2313901 also covering applications of WVA 23330

*Abdeckung von 2313901 auch für Anwendungen von WVA 23330*

TEXTAR 23139

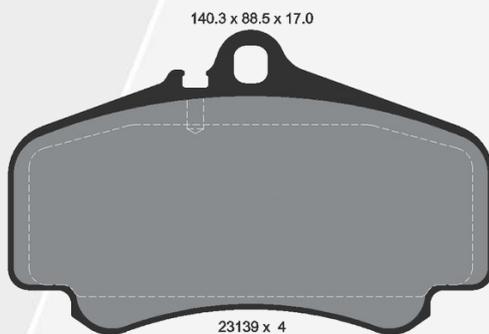
Textar used to supply 2313901 to Porsche for OEM and OES in the past. A change of the supplier in the OE supply chain caused a requirement for a technical change, because the new friction material tended to create noise. In the course of this additional weights were added. This turned WVA 23139 into WVA 23330. The functional dimensions have not been adapted. The friction material used for Textar does not require these additional weights. Therefore 2313901 can still be used and also covers the applications of WVA 23330.
